ADDENDUM #3

NORTH PLATTE COMMUNITY COLLEGE SOUTH CAMPUS CAFETERIA ADDITION NORTH PLATTE, NEBRASKA 1001

Date Issued: March 21, 2013

LAVATORY: L-1

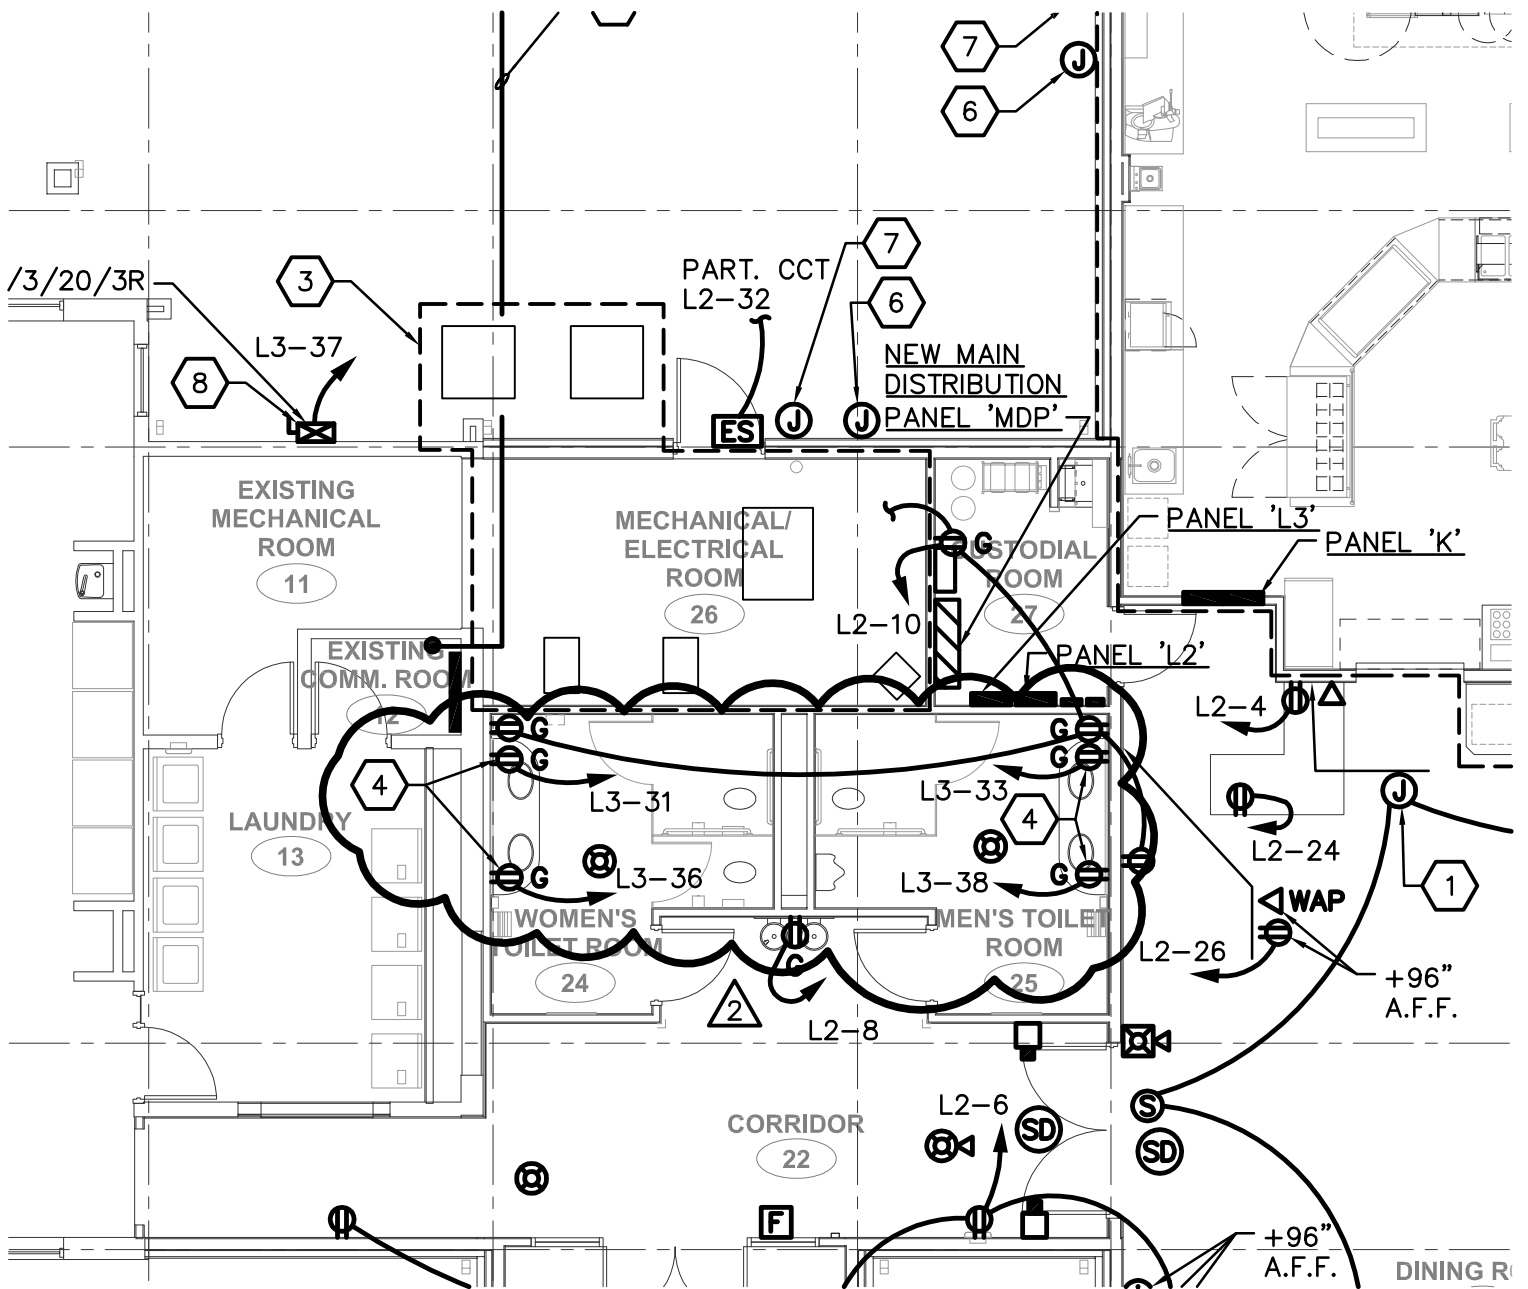
- Addendum #3 - #2** **SPECIFICATION SECTION 22 4000 – PLUMBING FIXTURES**
Replace the L-1 specification page with the attached new L-1 specification.
- Addendum #3 - #3** **SHEET A1.0 – FLOOR PLAN**
1/A1.0 FLOOR PLAN – FIRST FLOOR: At WOMEN’S TOILET ROOM 24 and MEN’S TOILET ROOM 25 delete the solid surface countertop and lavatory(ies), the soap dispenser(s), and the hand dryers and substitute the Advocate AV-60 wash fountain by Bradley. The wash fountains are specified in the plumbing specifications and are to be provided and installed by the plumbing contractor.

BRADLEY "ADVOCATE" AV60-2A-3-1-HD1-D-PD.

POWER PLAN - FIRST FLOOR
 SCALE: 1/8" = 1'-0"

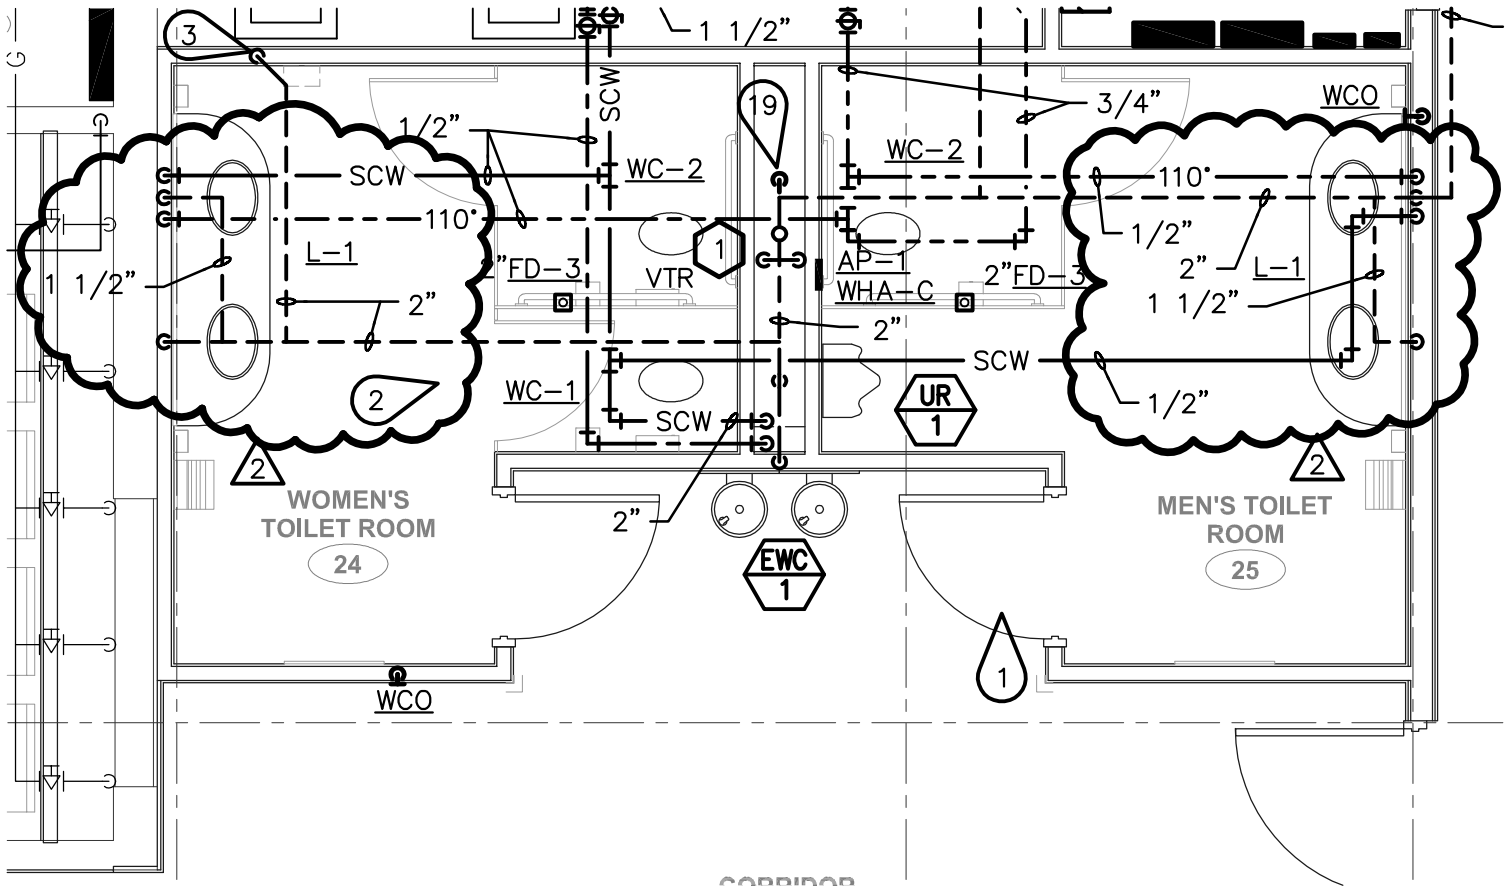
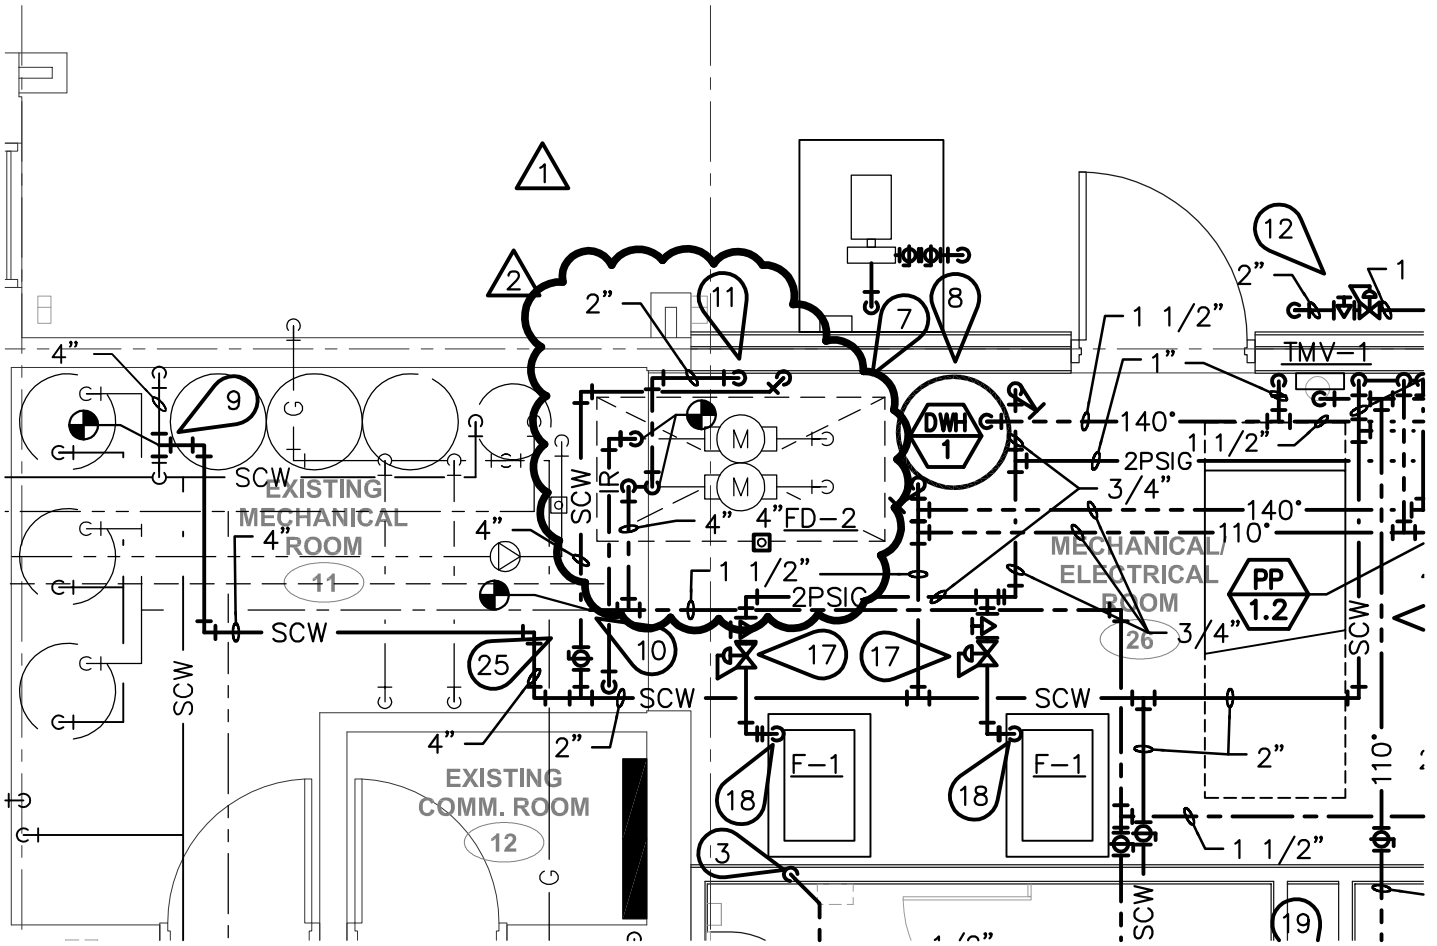
- Addendum #3 - #16 SHEET EP1.1 – POWER PLAN – FIRST FLOOR**
See attached supplemental drawing E-SK-1 for revised layout.

(4) COORDINATE LOCATION OF RECEPTACLES WITH MANUFACTURER'S SPECIFICATIONS PRIOR TO ROUGH-IN.

PARTIAL PLUMBING PLAN - FIRST FLOOR
 SCALE: 1/4" = 1'-0"

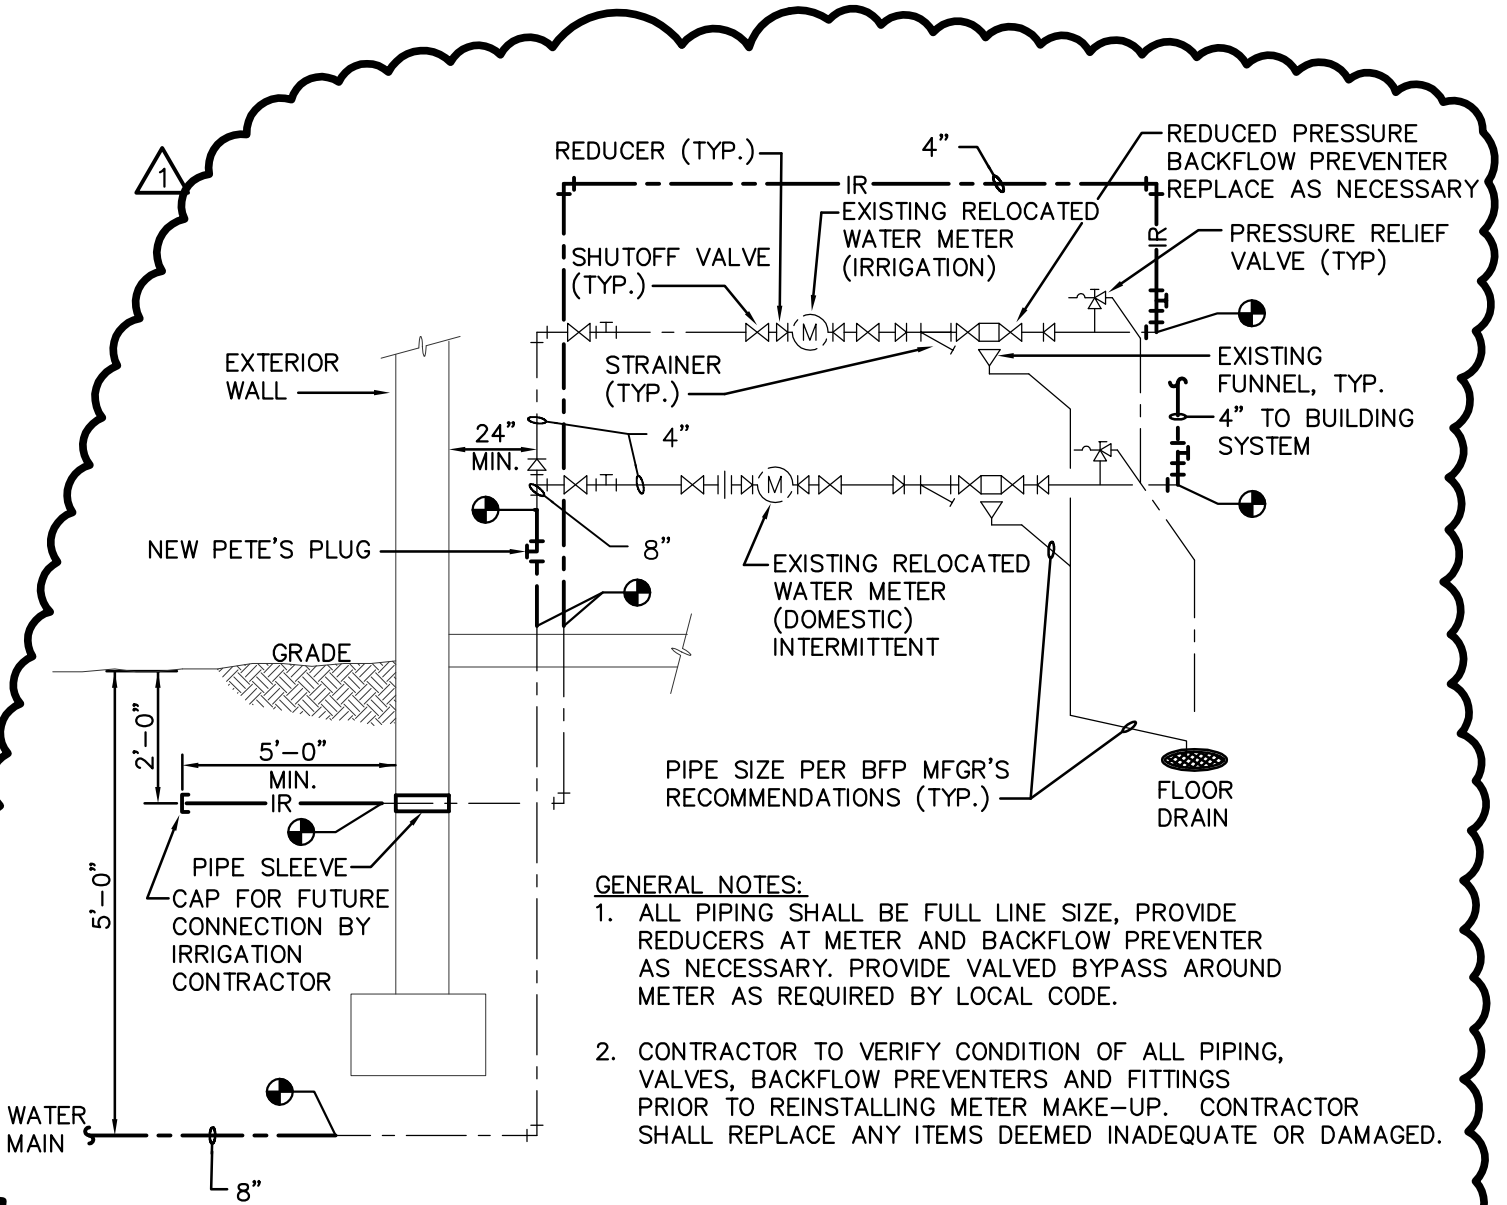
- Addendum #3 - #12 SHEET P4.1 – PARTIAL PLUMBING PLAN – FIRST FLOOR**
See attached supplemental drawing P-SK-3 for revised piping and L-1 fixture location.

- Addendum #3 - #13 SHEET P4.1 – PARTIAL PLUMBING PLAN – FIRST FLOOR**
See attached supplemental drawing P-SK-4 for revised water service piping layout.

-   NEW DOMESTIC WATER SERVICE ENTRY WITH RELOCATED METERS AND BACKFLOW DEVICES. SEE DETAIL 7/P5.1 FOR INSTALLATION REQUIREMENTS. CONNECT NEW 8" DCW MAIN TO EXISTING PIPE AT PENETRATION THROUGH FLOOR. COORDINATE EXACT LOCATION.
-  CONNECT NEW 4" DCW LINE TO EXISTING 4" MAIN, SERVING EXISTING BUILDING IN THIS APPROXIMATE LOCATION.

WATER SERVICE ENTRY DETAIL

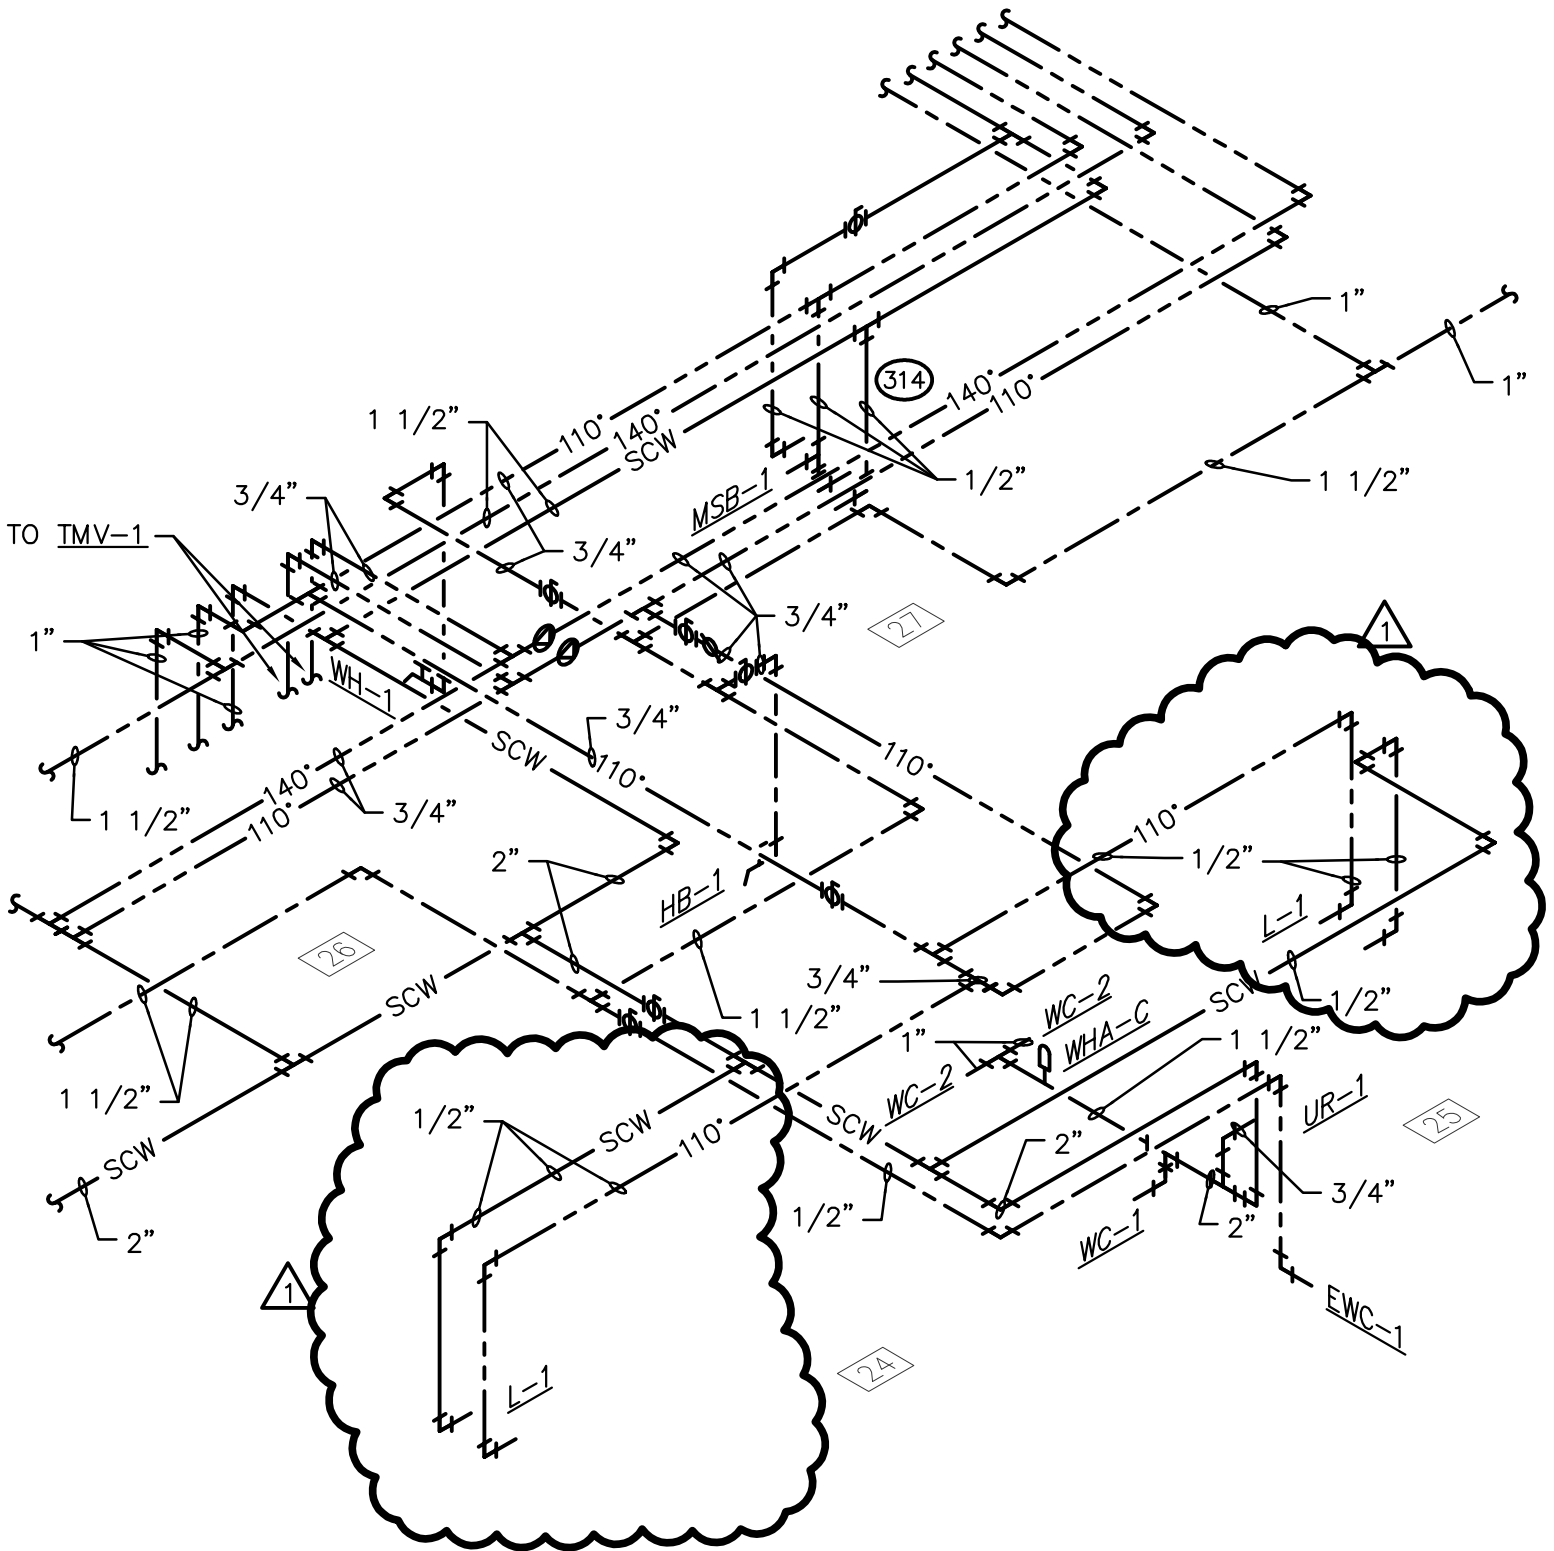
- Addendum #3 - #14 SHEET P5.1 – PLUMBING DETAILS AND SCHEDULES**
See attached supplemental drawing P-SK-5 for revised water service entry detail.
- Addendum #3 - #15 SHEET P9.1 – PLUMBING RISER DIAGRAMS**
See attached supplemental drawing P-SK-6 for revised piping riser diagram.

1. ALL PIPING SHALL BE FULL LINE SIZE, PROVIDE REDUCERS AT METER AND BACKFLOW PREVENTER AS NECESSARY. PROVIDE VALVED BYPASS AROUND METER AS REQUIRED BY LOCAL CODE.
2. CONTRACTOR TO VERIFY CONDITION OF ALL PIPING, VALVES, BACKFLOW PREVENTERS AND FITTINGS PRIOR TO REINSTALLING METER MAKE-UP. CONTRACTOR SHALL REPLACE ANY ITEMS DEEMED INADEQUATE OR DAMAGED.
